Planning Commission
June 18, 2024 - 6:00 PM
233 South Main Street, Monroe, Ohio

TO: Members of the Monroe Planning Commission
FROM: Jameson Cole
Planner
DATE: June 18, 2024
RE: Information Packet for June 18, 2024, Planning Commission Meeting at 6:00 p.m.

I. Case No. 2024-6-4—Consideration of a Site Plan for Marathon Gas Station

- Jake Rudemiller of Leesman Engineering, on behalf of Shops of Monroe Crossings LLC, have submitted a site plan application for a gas station and convenience store to be located at the southeast corner of State Route 4, Roden Park Drive, and Coldwater Drive.
- The applicant proposes a 3,500-square-foot building with a convenience store, drive-through, and automotive re-fueling stations.
- The proposed site is 2.29 acres and is zoned C-4 Gateway Commercial PUD.

Design: REB	Proj:
Draw: REB	Dwg:
Check: REB	Tab: L-1.1
Scale: AS NOTED	
Date: 3.14.2024	
Sheet: DETAIL LANDSCAPE PLANS	
Sheet No.:

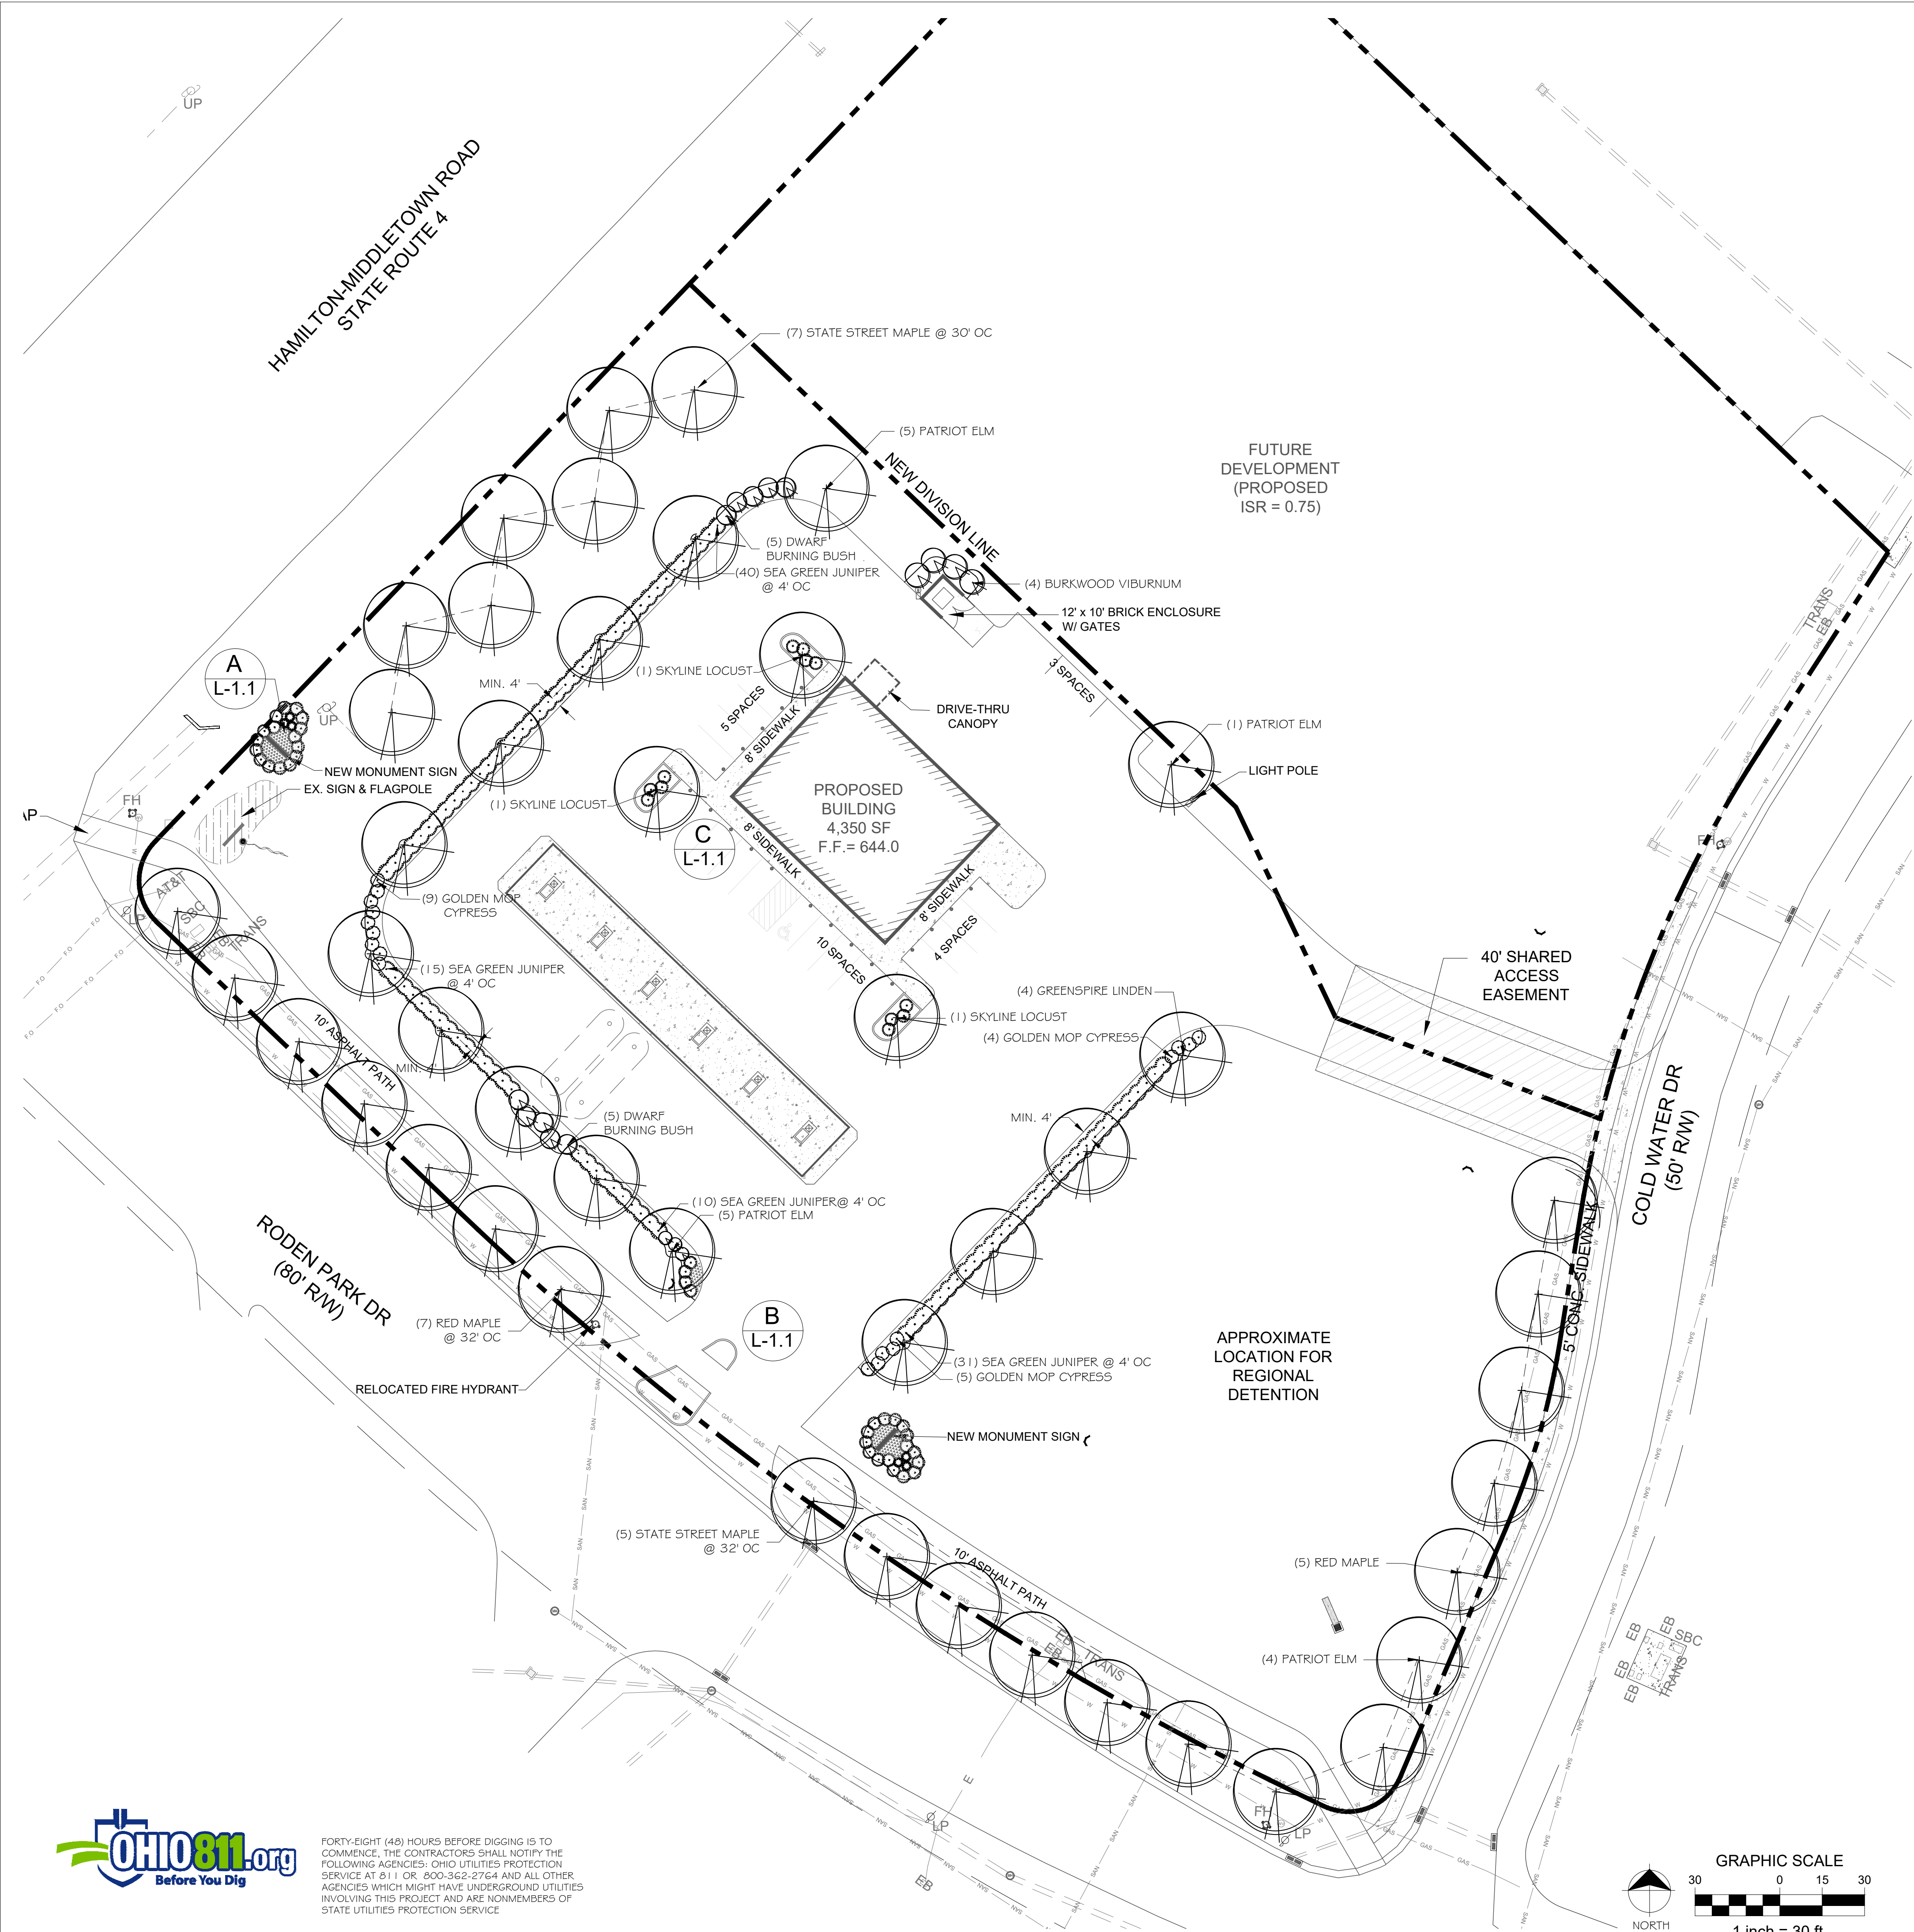
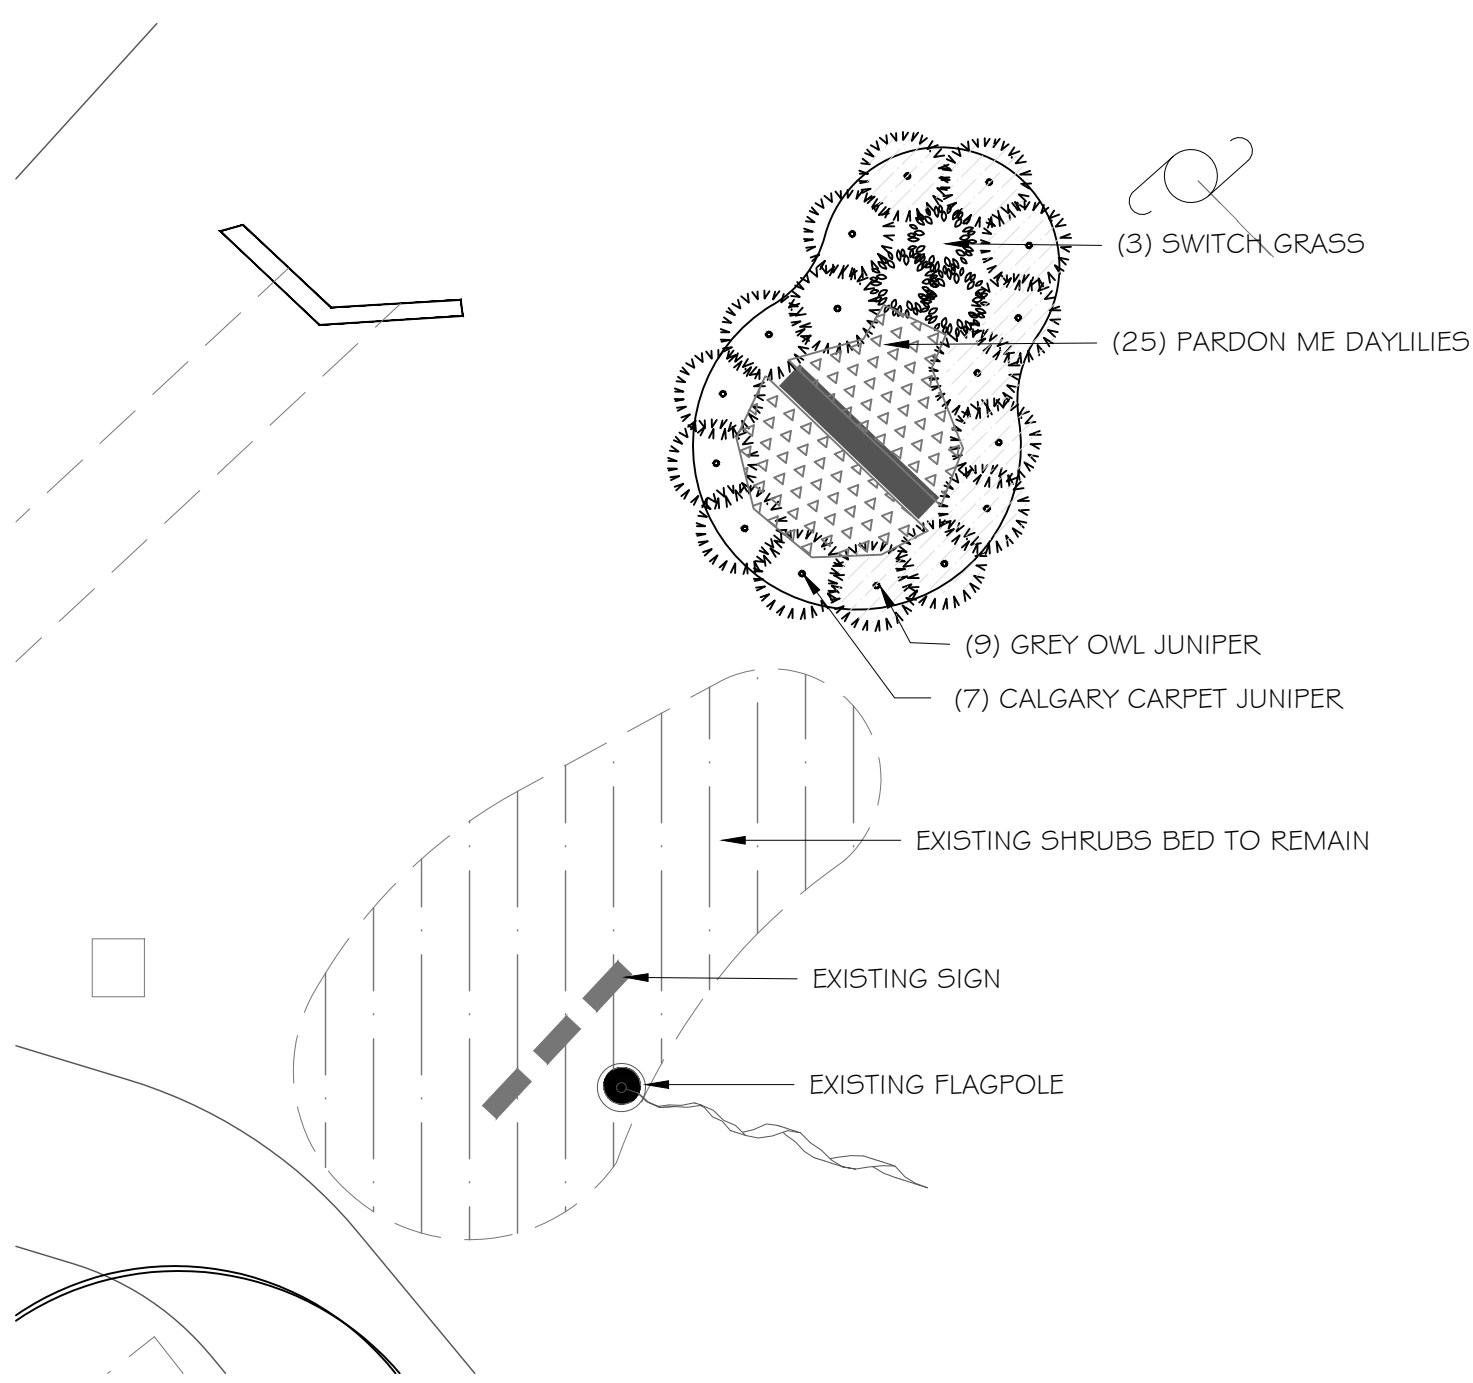
- **Street Trees—**
 - The street trees along Hamilton Middletown Road and Coldwater Drive need to be placed in the tree lawn between the sidewalk and the back of the curb.
- **Landscaping—**
 - The front yard landscaping is required to be a minimum of 20 percent of the required front yard area with a minimum 6-foot-wide area adjacent to the right of way.
- It appears that the trees required as part of the front yard landscaping are missing. Please revise to include trees within the required front yard area.
- **Sidewalk—**
 - The code requires sidewalks along all portions of a parcel that front a public or private street as well as a sidewalk connection to the use. The applicant does not show any connection from the sidewalk to the building.

- Staff recommends approval of the site plan application with the following conditions:
 - The landscape plan be revised based on staff comments to meet code standards.
 - As a reminder, minimum size and species requirements related to landscaping must be met.
 - As a reminder, if ground mounted or rooftop equipment becomes necessary in the future, screening will be required.
 - Revise the site plan to show a pedestrian connection between the sidewalk and the building.
 - All other Staff comments and any future Engineering review requirements are to be addressed.
 - A GIS compatible file of finalized plans be submitted.
